CITY OF BLACK DIAMOND
November 30, 2017 Special Meeting Agenda
25510 Lawson Street, Black Diamond, Washington

STAFF REPORT – PLN17-0076 Ten Trails Phase 2 Plat C – Division 1 Final Plat

Name of Subdivision: Ten Trails Phase 2 Plat C – Division 1 (One)

WETLAND BUFFER REVEGETATION PLAN

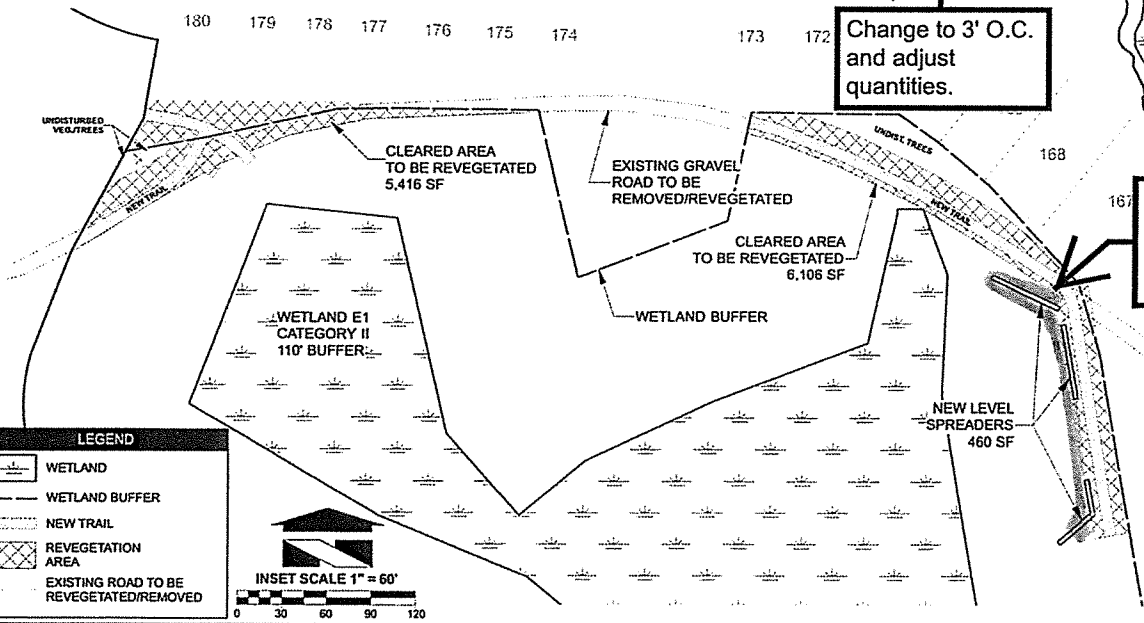
Change to 3' O.C. and adjust quantities.

Add/quantify additional cleared areas in green. See memo.
